**RE: Public Exhibition of Draft Wilton Growth Area Development Control Plan 2019 (DCP)**

I refer to the invitation to comment on the Draft Wilton Growth Area Development Control Plan 2019 (DCP). WaterNSW has previously provided advice on the development application (DA) for the Stage 1 development of the South East Wilton Precinct.

**Figure 1.** South East Wilton Precinct showing location of Upper Canal Corridor, Metropolitan Special Area and drainage features.

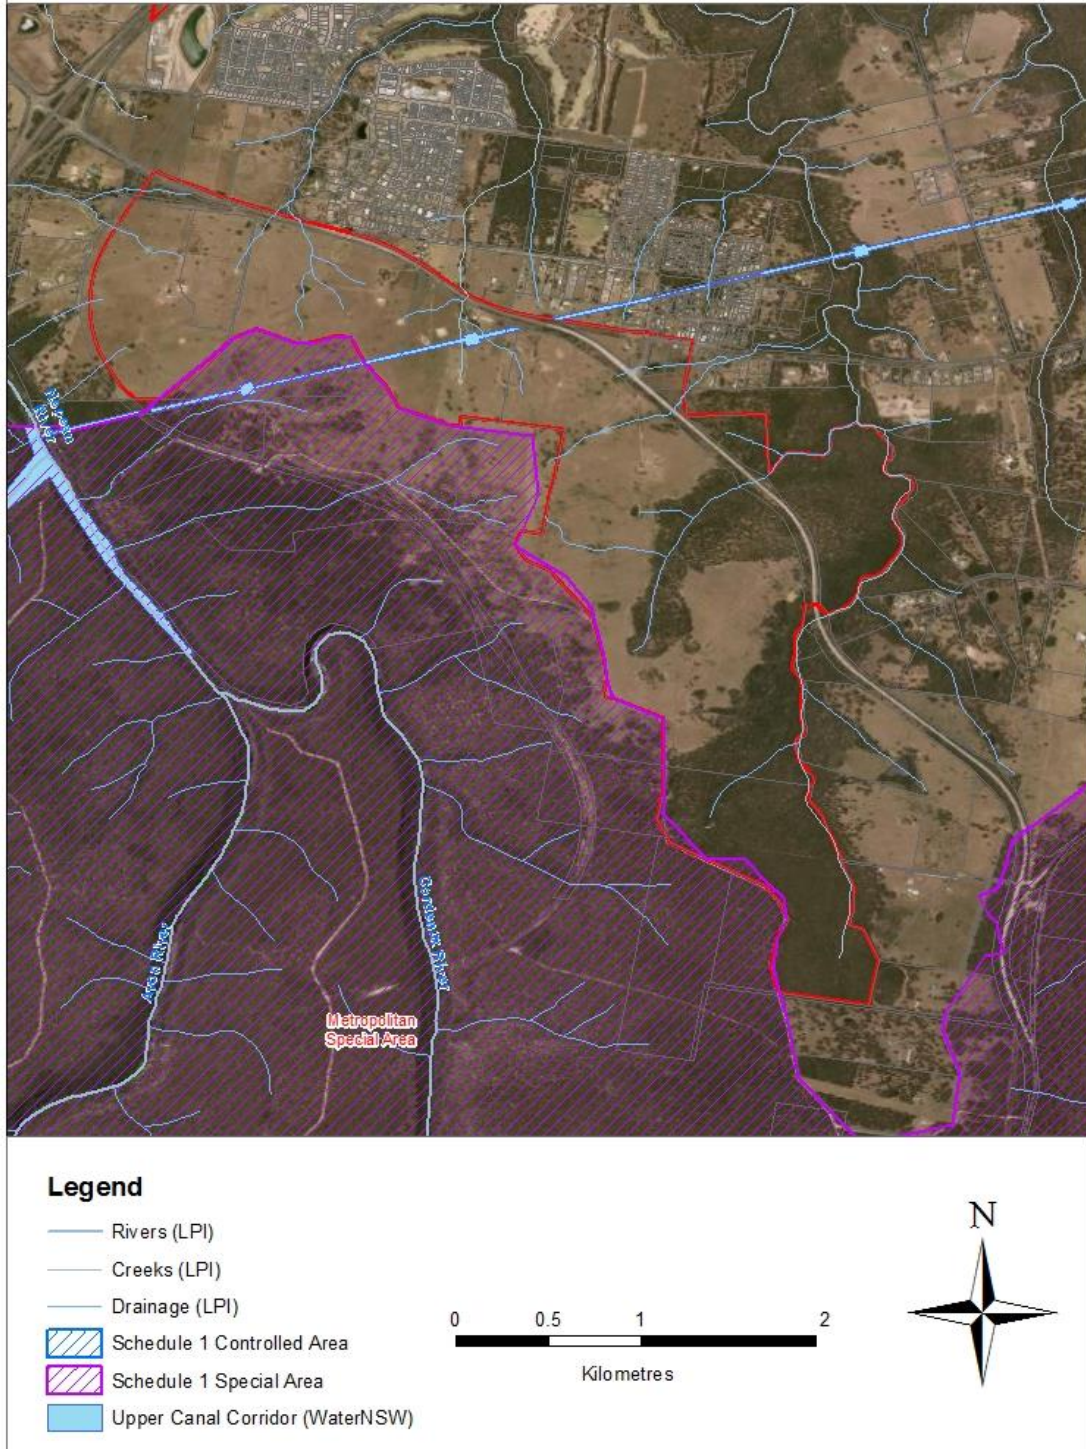
- The Flood-Prone and Riparian Corridor Map for the South-East Precinct (Figure 3-7 of Schedule 1) does not depict all the drainage features. Figure 1 (of this letter) shows the drainage features within the Precinct and the respective locations of the Metropolitan Special Area and Upper Canal Corridor.

A number of drainage features transect the Upper Canal Corridor and may be subject to increased risk of stormwater runoff as a result of the Precinct's development. There are also drainage features within the Metropolitan Special Area that lie close by to the Precinct's southern boundary, and which drain into the Nepean River above Pheasants Nest Weir. These drainage elements are important for water quality protection given the proximity of these features to the commencement of the Upper Canal at Pheasants Nest Weir.
